Re: Request for Information Pursuant to Section 308 of the Clean Water Act (33 U.S.C.

§ 1318), Docket No. CWA-308-R01-FY20-31 from Brayton Point LLC. Permit ID

MAR05J01C (Somerset, MA)

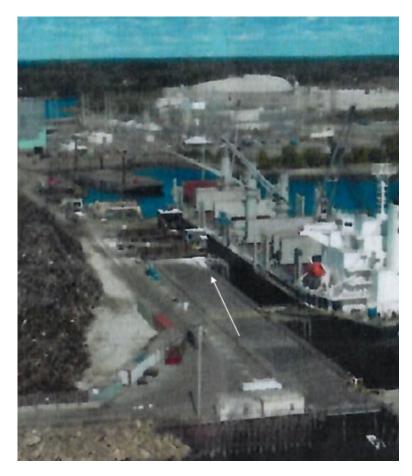
- (3) Update the SWPPP and map accordingly to include all stormwater conveyances and best management practices from the fueling area.
- f. The photo dated September 27, 2019 within the SWPPP appears to show a pile of salt on the edge of the dock, next to an unloading hopper (see photo below):

- (1) Explain what standard practices are implemented to minimize spillage of salt into the Taunton River while unloading from a cargo ship;
- (2) Provide the dates when offloading of salt occurred at the Facility from the date Brayton point LLC took ownership of the site until the present; and
- (3) On what frequency is salt that escapes the hopper cleaned up.
- g. Form-3 Stormwater sampling, analysis protocols, and reporting requirements, the following list of analytes are included:
